Coal Combustion Residue Impoundment

Round 9 - Dam Assessment Report

L.V. Sutton Steam Electric Plant

Ash Ponds

Figure 7.1.2a: 1971 Ash Pond – Typical Stability Analysis Section (B-2)

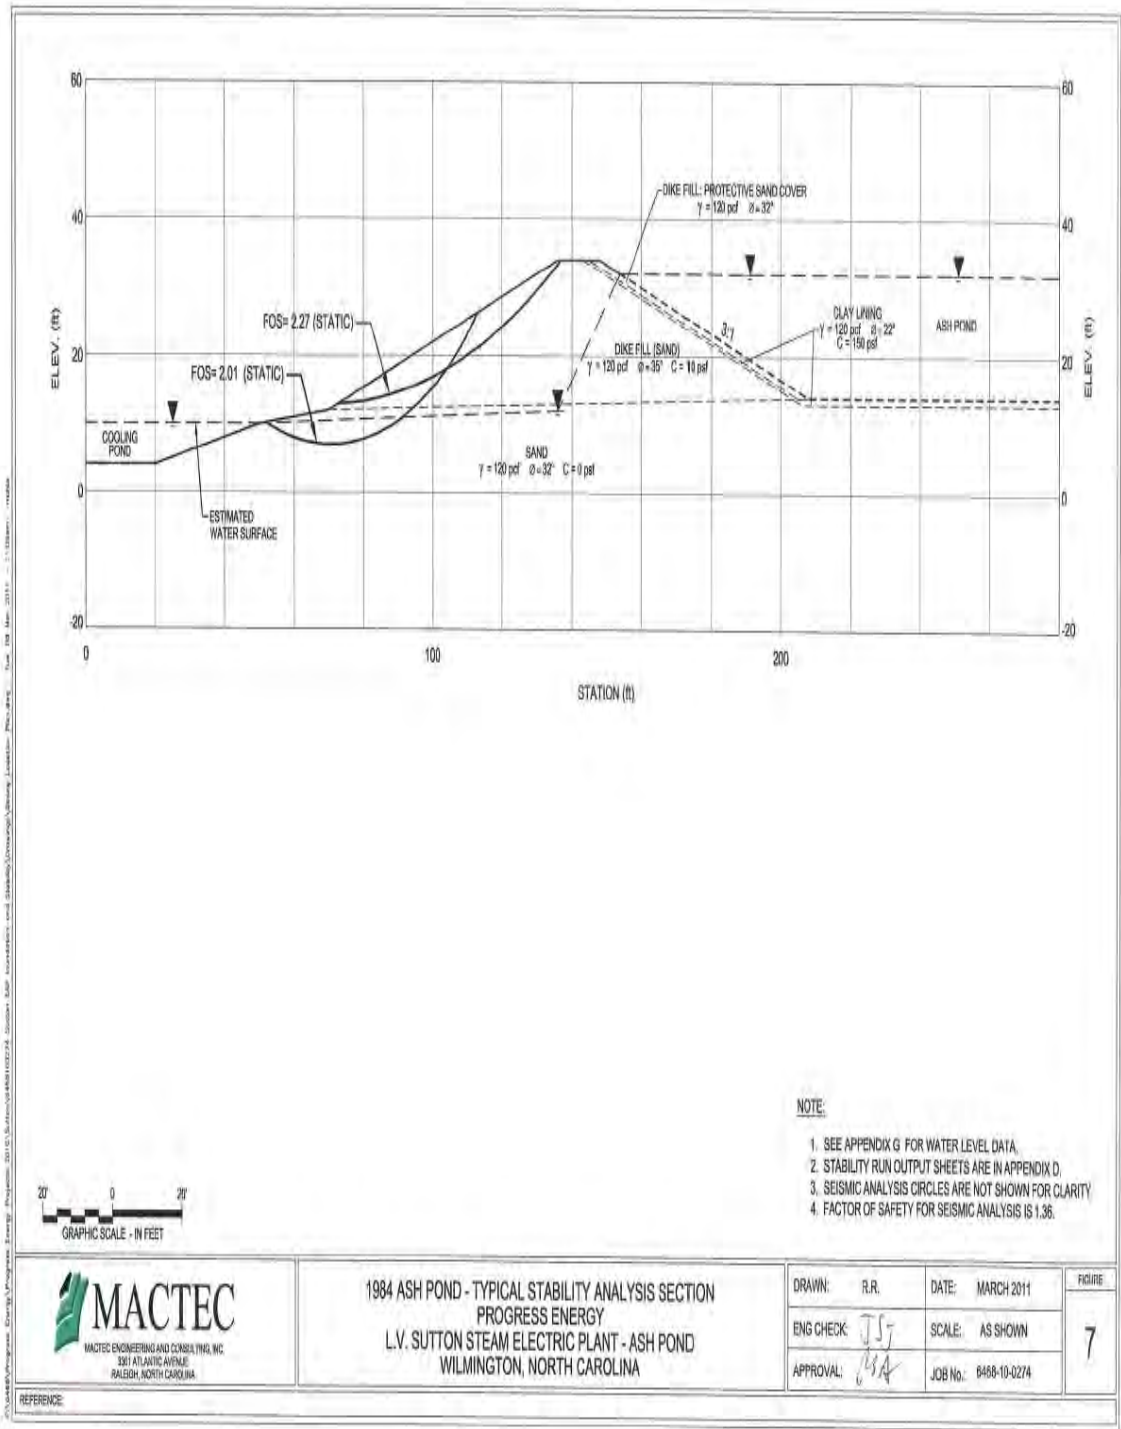
Develop a plan of action to address the insufficient factor of safety along the 1971 ash pond embankment.
